SUBJECT: Starwood Power Plant Project (06-AFC-10C) Staff Assessment of Proposed Modifications to Drill a Well, Reposition Structures, Increase Stack Height and Add a Storm Water Retention Pond

STARWOOD POWER PLANT

**Amendment No.1 (06-AFC-10C)
Fresno County**

STAFF REPORT

PROJECT DESCRIPTION – FIGURE 1 Starwood Power Project Amendment 1

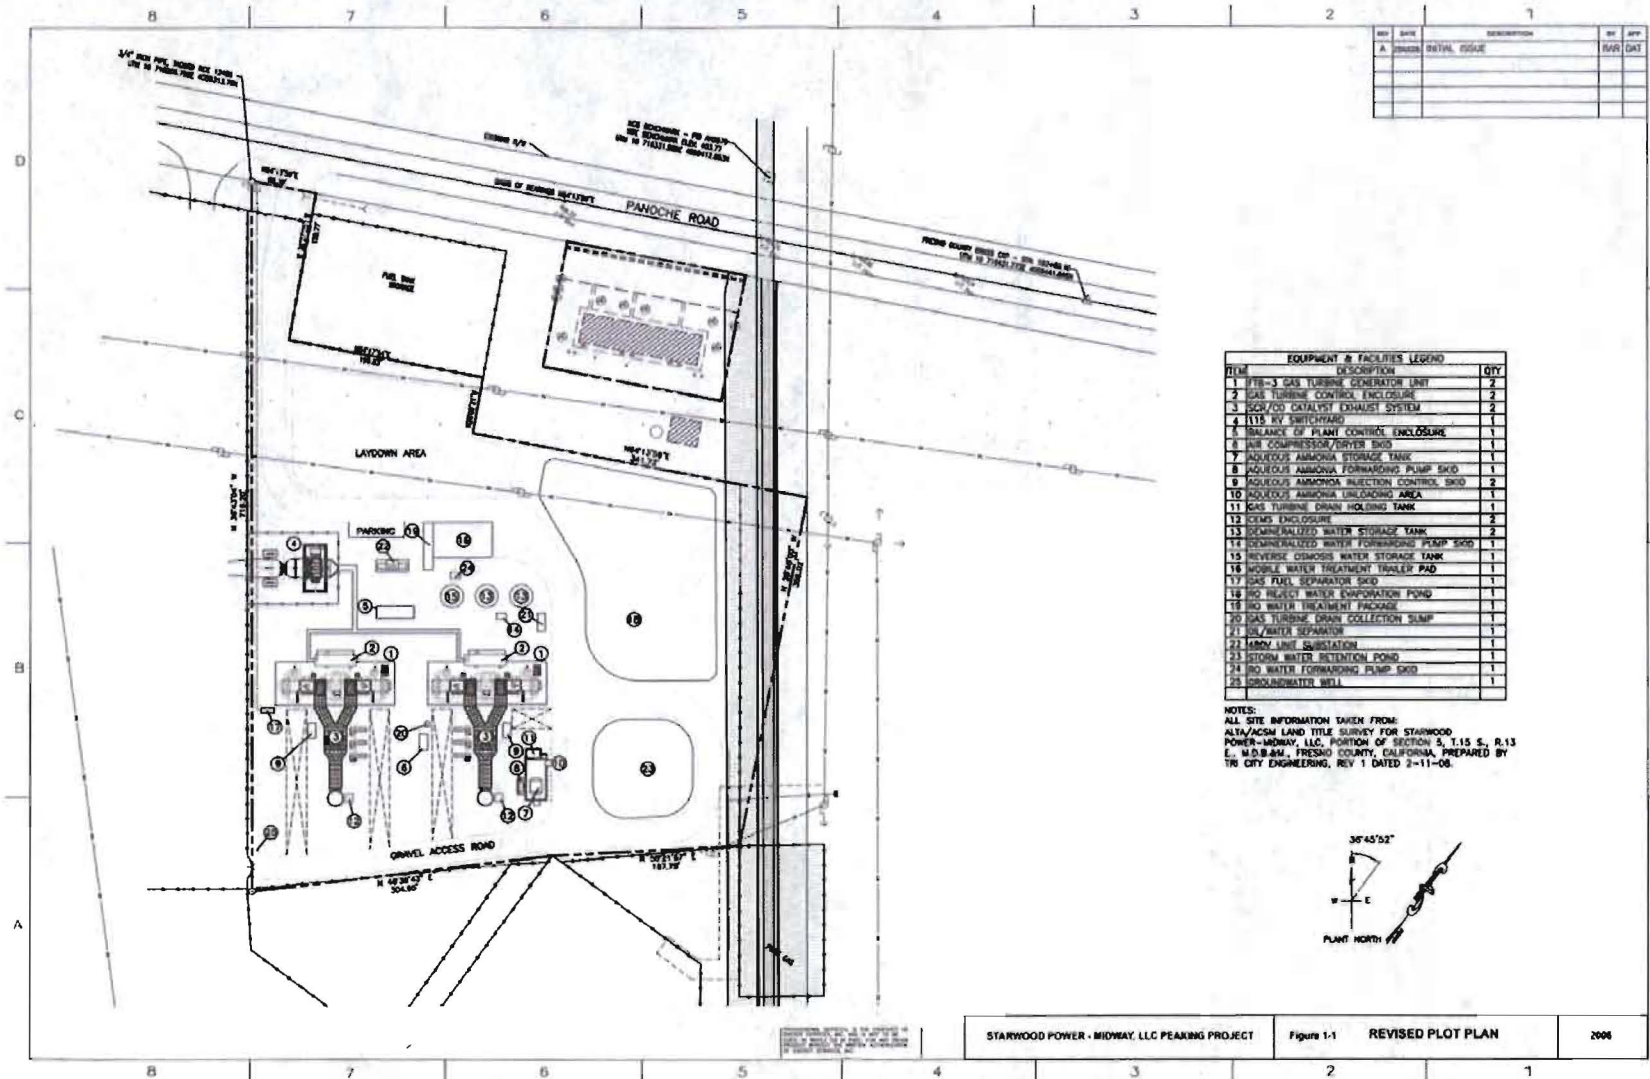
The site plan (**see Project Description Figure 1**) illustrates numerous minor changes to the layout of the proposed generation facility. The size and boundaries of the 5.6-acre project site have not changed in this amendment petition from those approved in the Final Commission Decision for Starwood, but many elements within the site have been reconfigured.

- Combustion turbine generator (CTG) Unit 1 has been moved approximately 19 feet west. Both CTG units have been moved 5 feet south. This will increase the space between CTG units for maintenance and allow the installation of underground electrical duct banks.
- The gas turbine drain collection sump has been shifted east and reduced in size to avoid the underground duct banks.
- To avoid the underground duct banks and a 15kV trench, the Balance of Plant (BOP) control enclosure (controls for things other than the combustion turbines

- The CTG holding tank has been shifted 34 feet to provide maintenance access to GT #2A, which is a designated area on the east side of the CTG Unit 1, between Unit 1 and the CTG drain holding tanks, to allow adequate space for a crane for turbine removal.

- The access road was modified to account for the pond reconfigurations and to avoid a high voltage transmission pole located in the middle of the site. A gravel road was also added to the south side of the units for a secondary path of egress from the site to address permit requirements.
- The Construction lay down area has been increased from 11,050 square feet to 20,000 square feet within the revised site plan.
- The parking area length has been reduced to 70 feet from 110 feet. The parking area has also been repositioned. It is now located south of the construction laydown area and north of the 480 volt unit substation.
